179 PLEASANT STREET
PORTSMOUTH, NEW HAMPSHIRE

HDC APPLICATION TO AMEND PREVIOUS APPROVAL: MARCH 2, 2022

LETTER OF AGENDA

We respectfully submit this Application for Amended Approval. The current HDC Approval was granted to the prior owner.

PROPOSED MANSION DORMERS - EAST ELEVATION

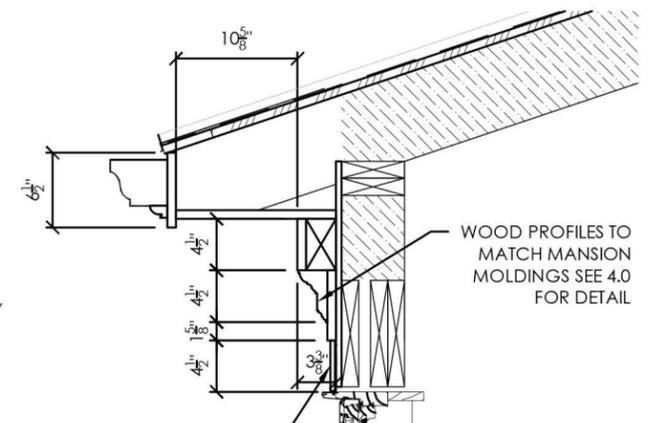
WOOD PROFILES TO MATCH MANSION MOLDINGS SEE 4.0 FOR DETAIL

WOOD HEAD CASING TO BE 1" X 5 1/2"
JAMBS TO BE 3/4" X 5" AS REQUIRED BETWEEN RADIAL WINDOW INSTALLATION

MARVIN ULTIMATE CASEMENT: UCA 3678 ET
3'-1" X 6'-5 5/8"

WOOD SILL TO MATCH ANNEX SILL PROFILE - SEE 6.1

WOOD CLAPBOARD SIDING TO MATCH EXISTING MANSION

Main entry portico column base

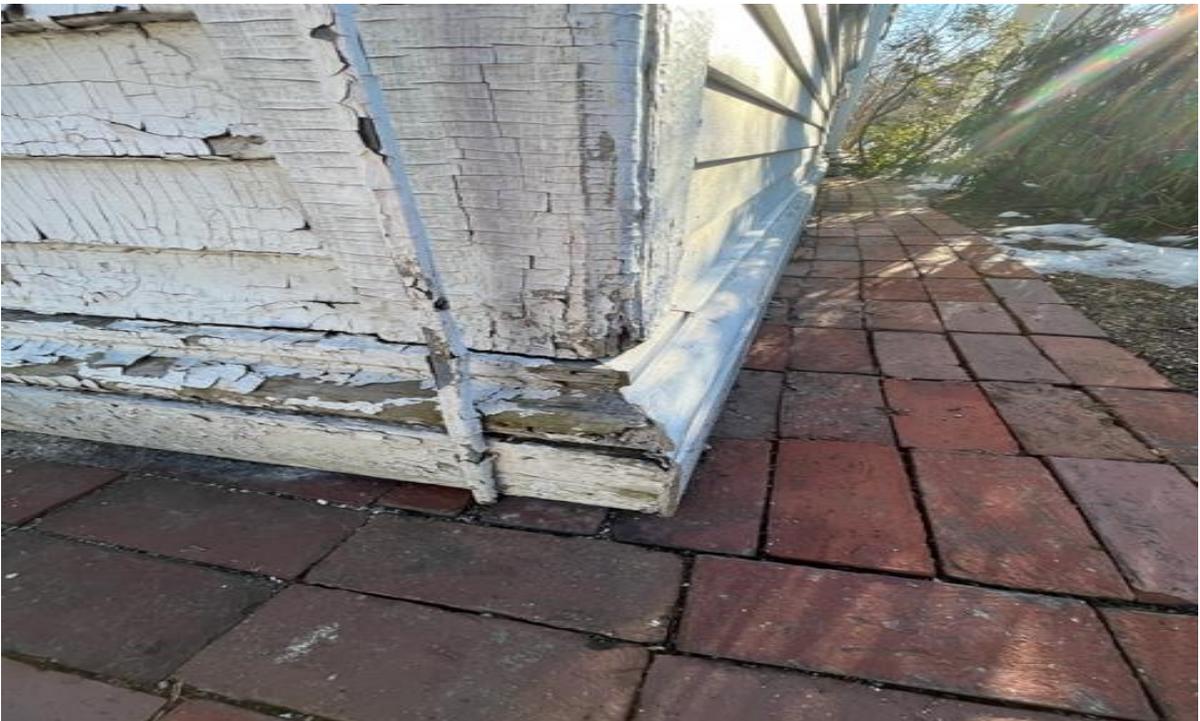
Proposed column and pilaster base construction. This is to only illustrate how the new bases will be made. 1-piece solid PVC
